January 7, 2019

RE: **Hollywood Hills Plaza Outparcel – 4,500 S.F. Commercial Building**
Hollywood, Florida
File # 18-DP-34

Below are our responses to the City's comments for the above referenced project:

1 FLOOR PLAN
SCALE: 1/8" = 1'-0"

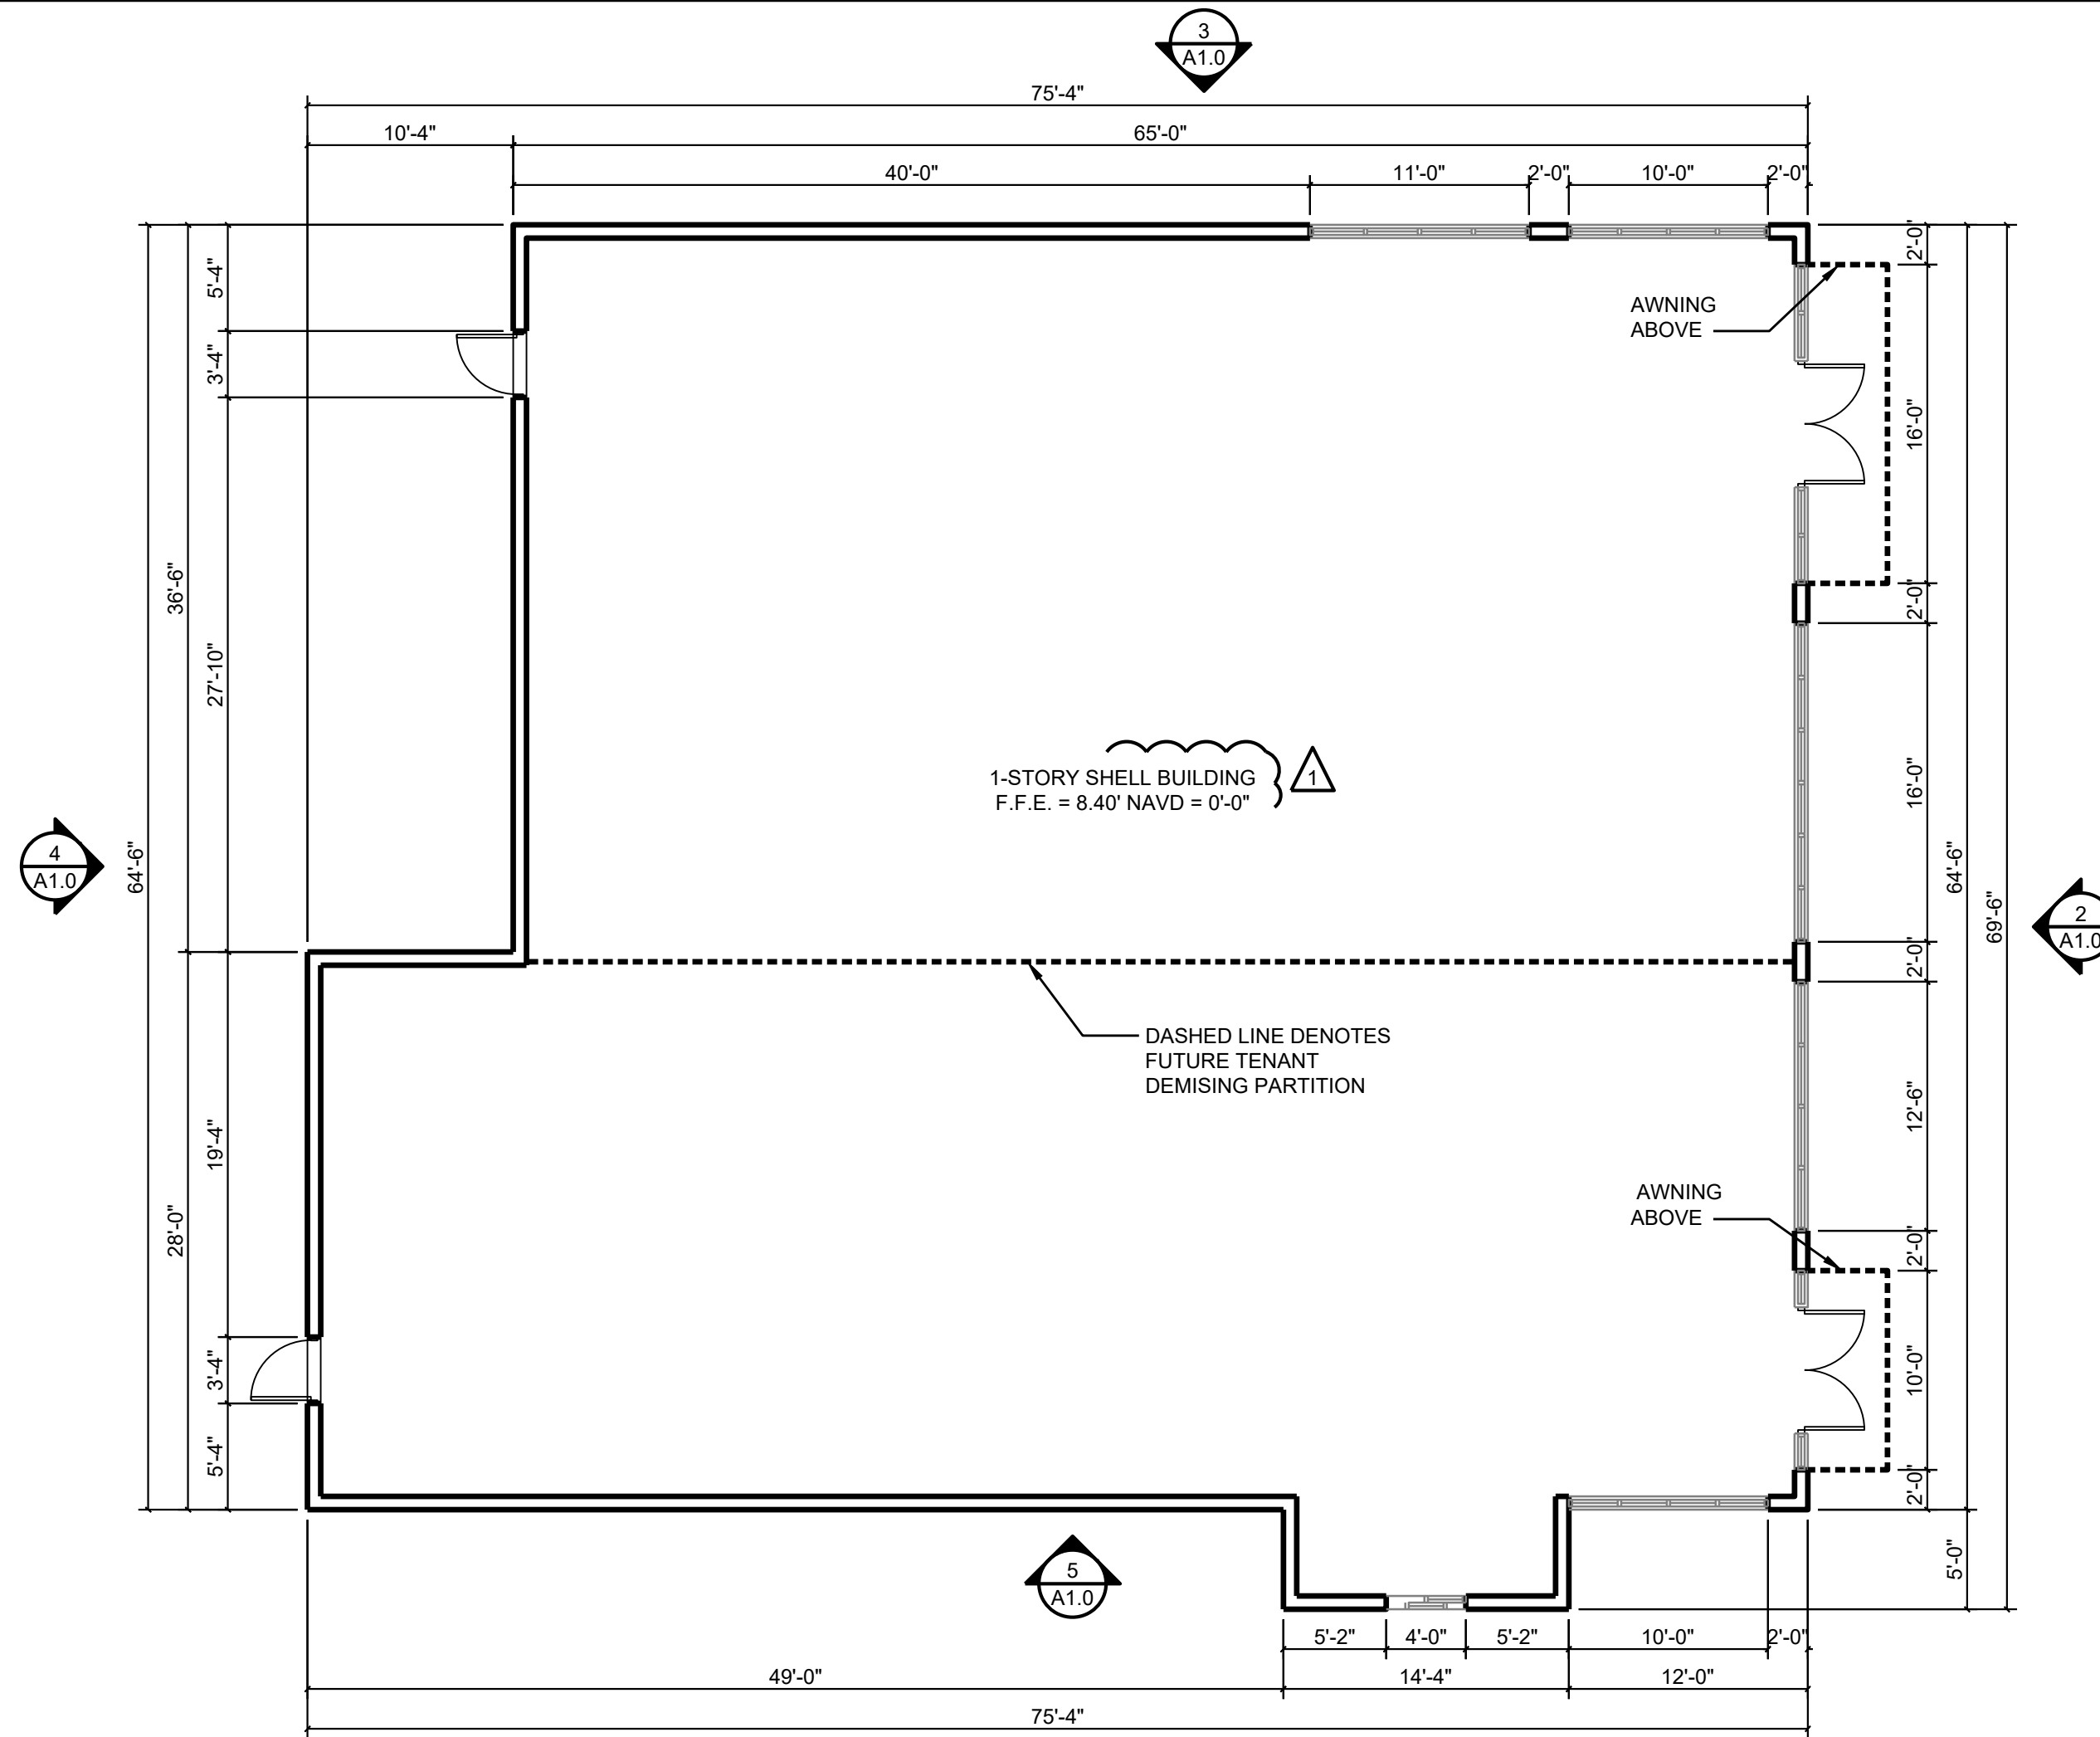
1. Comment: Include Elevation marker indicating established grade
Response: *The elevation marker has been added to the floor plan on sheet A1.0.*
2. Comment: Given the outparcel's location within a shopping complex, the project should incorporate addition architectural articulation on the north and west facades
Response: *The client is studying their options internally and will address this issue at final TAC meeting.*

PAVING, GRADING & DRAINAGE PLAN

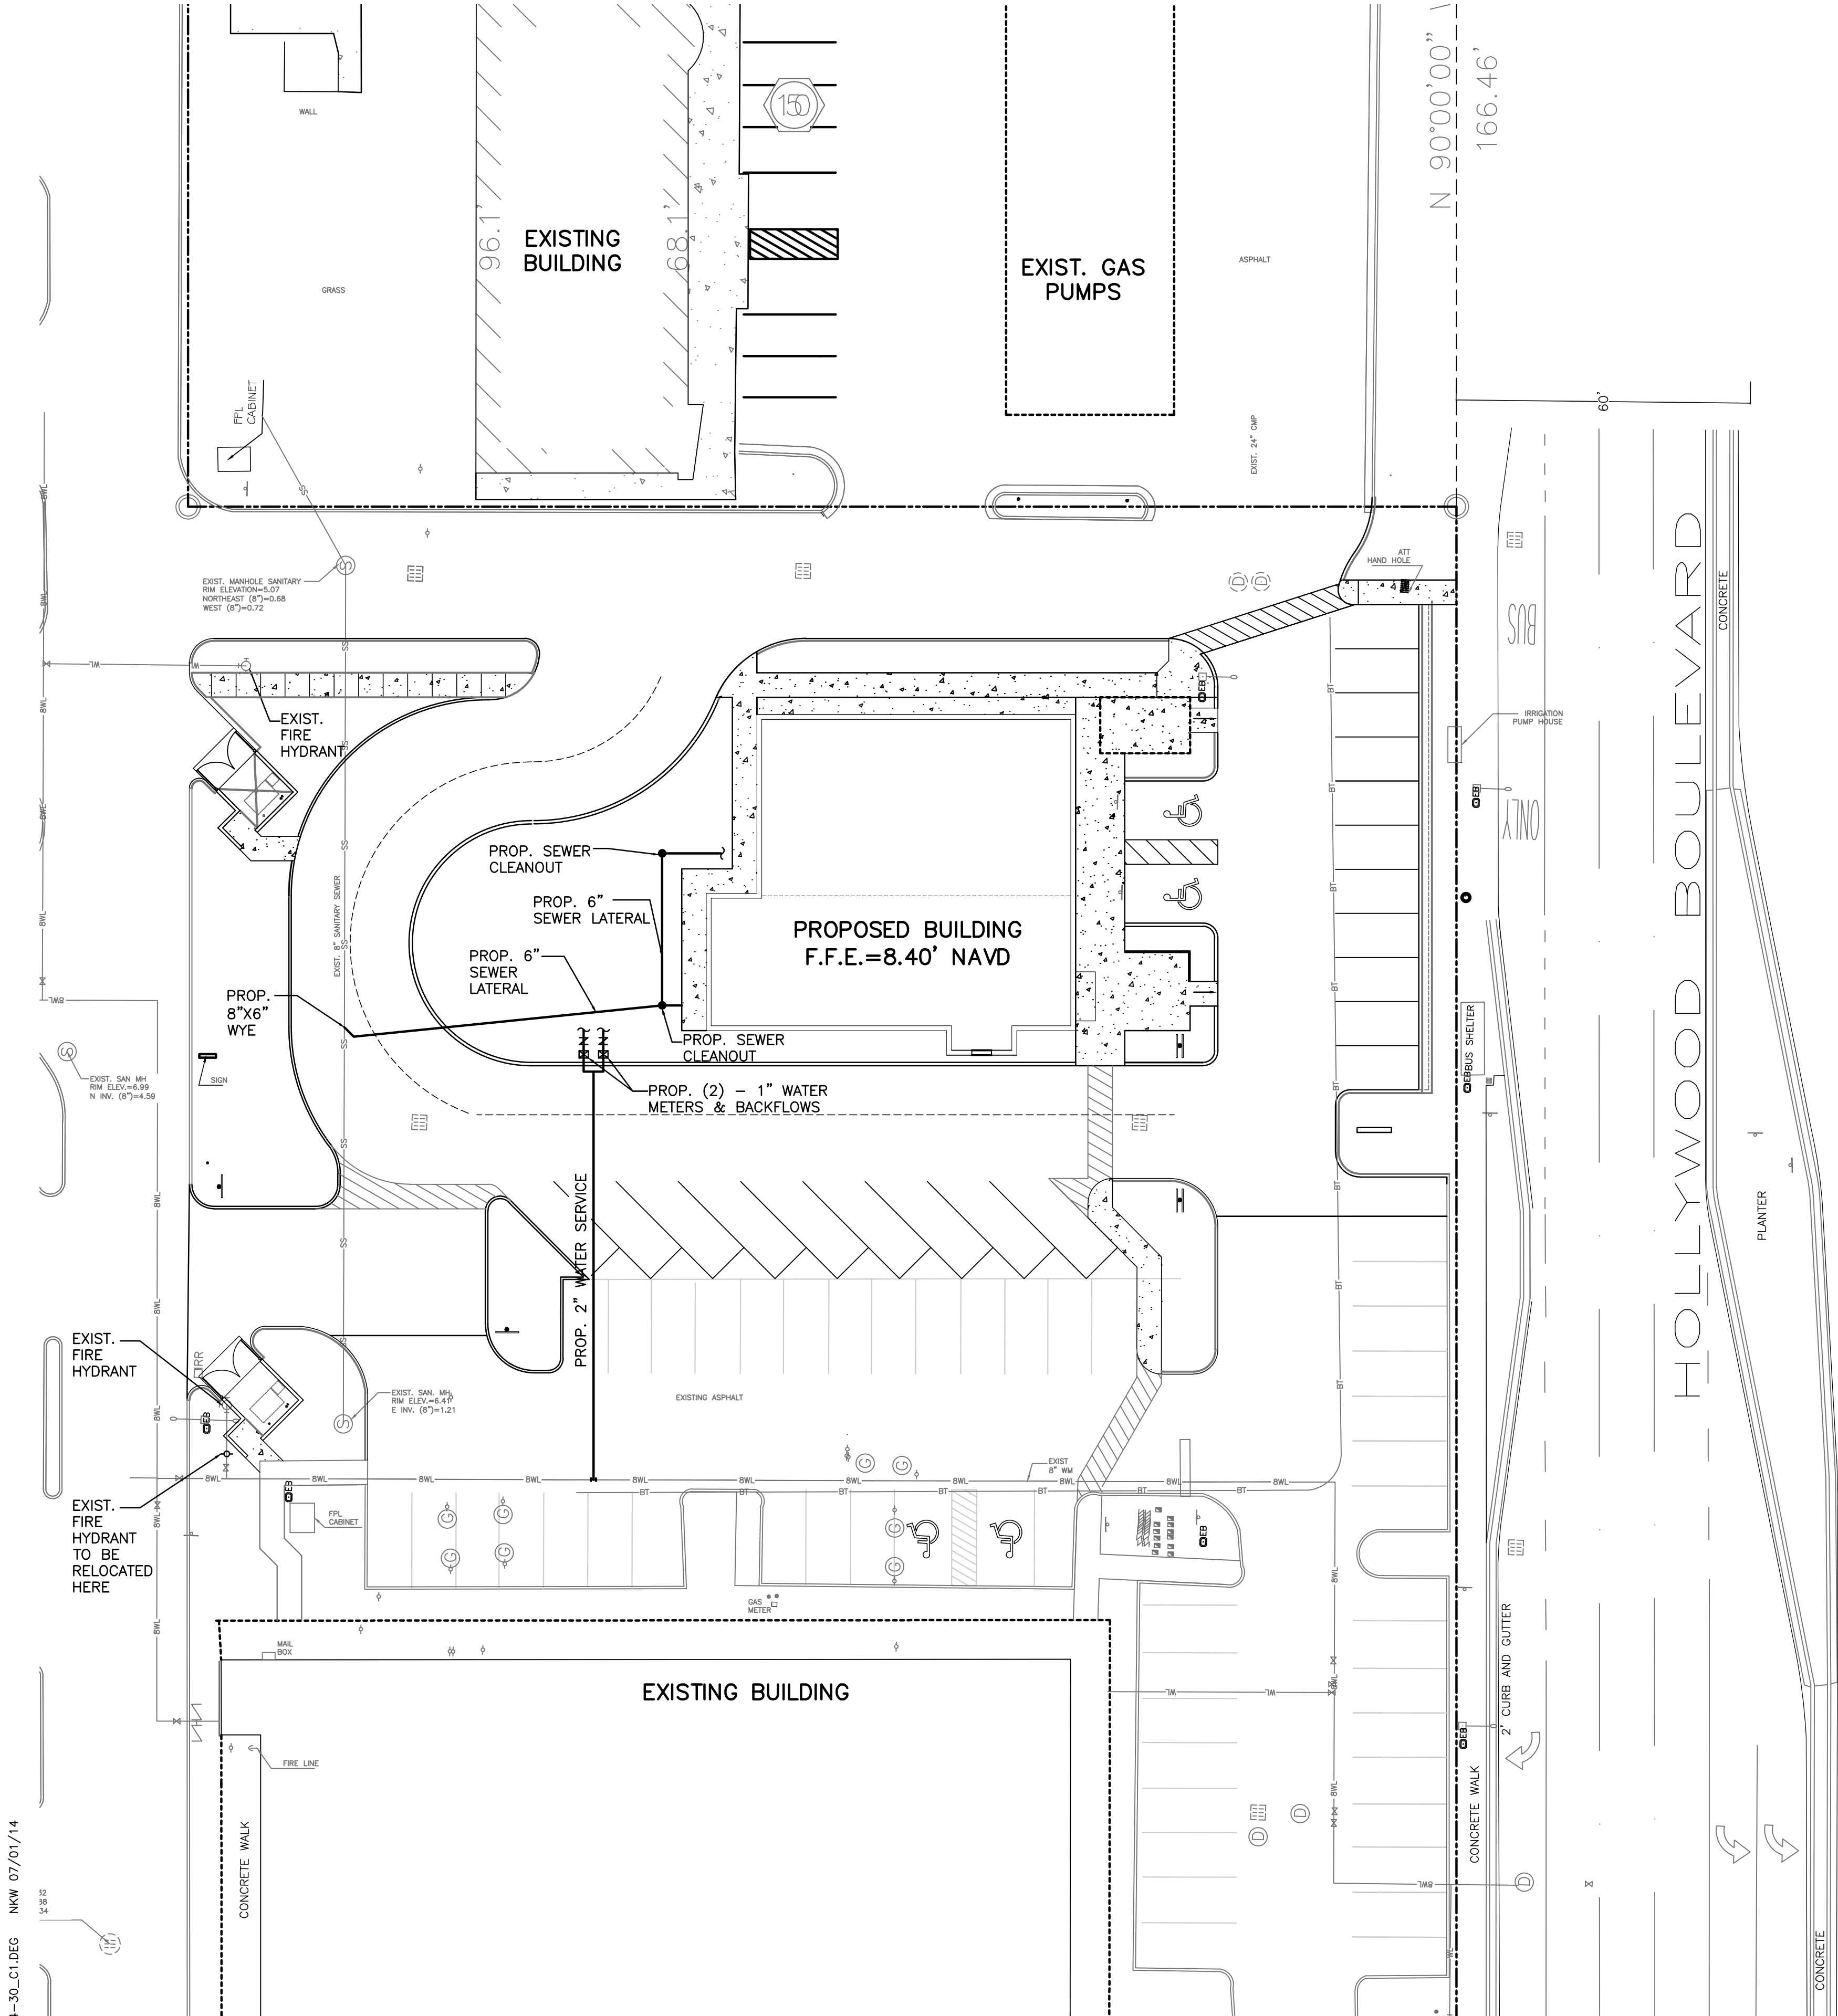
- Response:** *Please refer to attached updated survey.*
2. **Comment:** The north arrow on sheets C1-C4 is pointing in the wrong direction. Adjust accordingly.

- Response:** *Revised as requested. Refer to updated drawings.*
4. **Comment:** Indicate the scale of the drawings on sheets C1-C4.
- Response:** *Revised as requested. Refer to updated drawings.*

- Response:** *Revised as requested. Refer to updated sheets C1-C4.*
3. **Comment:** The hatch for the concrete walk along the south side of the building appears to be incorrect. Review and revise accordingly.
